SB-10048279-9800
Service Campaign Bulletin

Campaign No. 2012070002, September 2012

SUBJECT: **Models 164, 171, 203, 204, 207, 209, 211, 212, 216, 219, 221, 230, 251, 463**
Engines 272 and 273
Model Years 2005 - 2011
Retrofit Adapter Wiring Harness on Camshaft Adjustment Solenoids

Figure 1

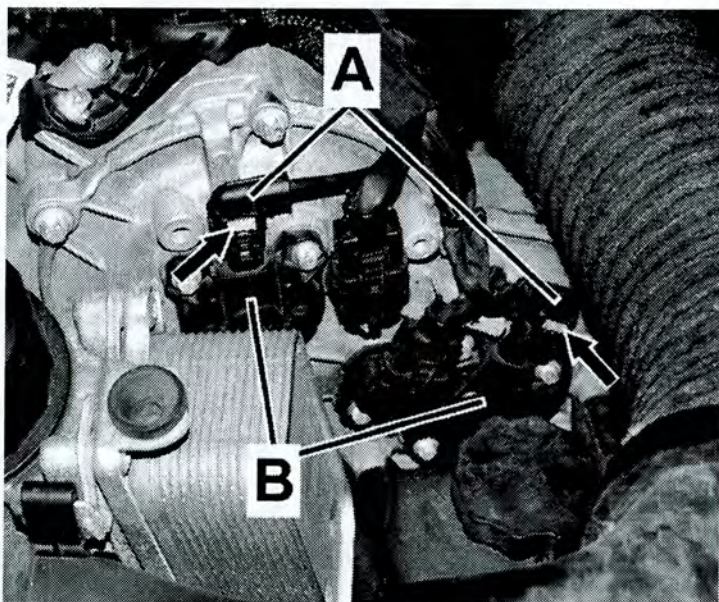
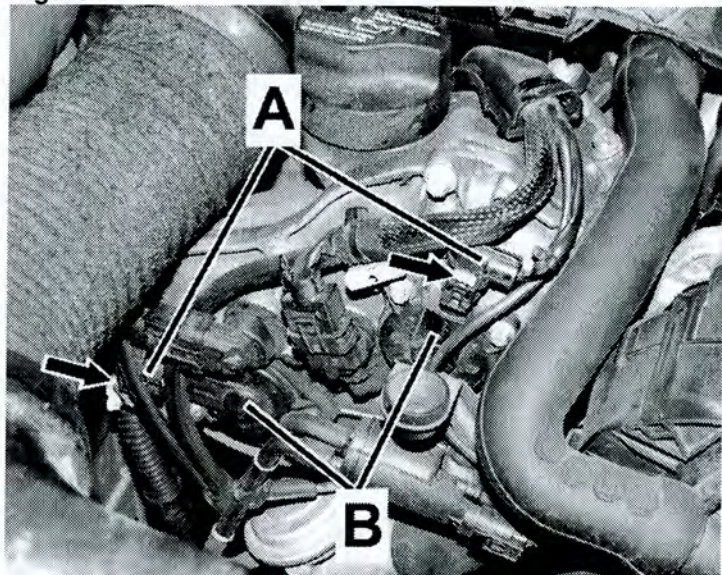
1. Remove top engine cover to get access to camshaft adjustment solenoids as required.
2. Disconnect camshaft adjustment solenoids from engine harness connectors (A, Figures 1 and 2):
 - Carefully unlock engine harness connectors (A) by squeezing and **partially** pulling out locking tabs (arrows) using pocket screw driver.
 - Disconnect camshaft adjustment solenoid connectors (A) from camshaft solenoids (B).

Figure 3

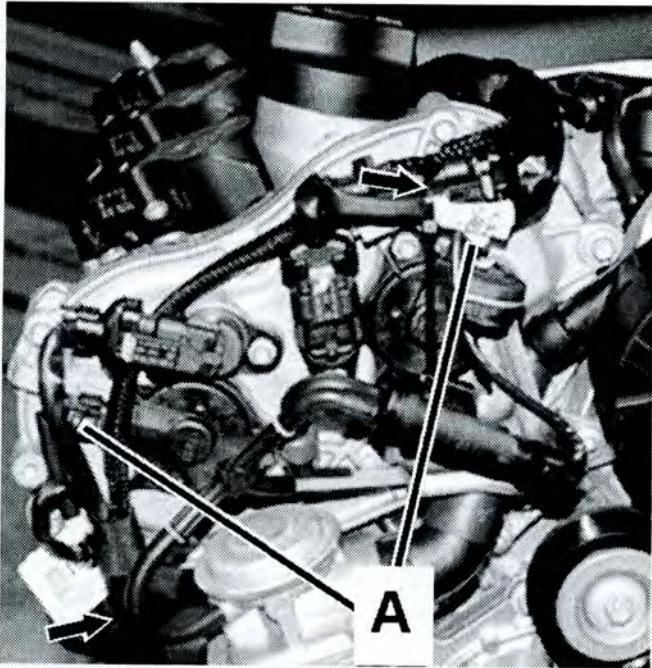
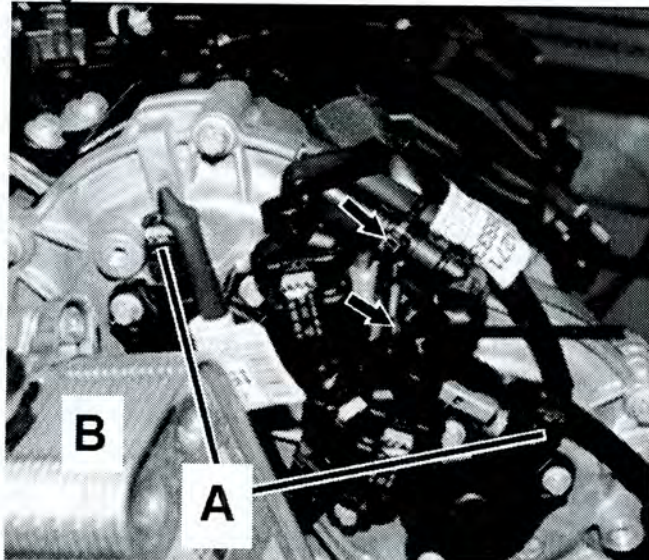
3. Connect adapter harnesses (A, Figures 3 and 4):
 - Connect adapter harnesses (A) between connector on camshaft adjustment solenoid and engine harness.
 - Push locking tabs (arrows, Figures 1 and 2) into connectors to secure (total of 8 locking tabs).
4. Secure adapter harnesses with cable ties.

Ensure harness adapters are properly secured using cable ties (arrows, Figures 3 and 4) to prevent wire chafing and/or damage from hot engine parts, (e.g. oil cooler [B]).
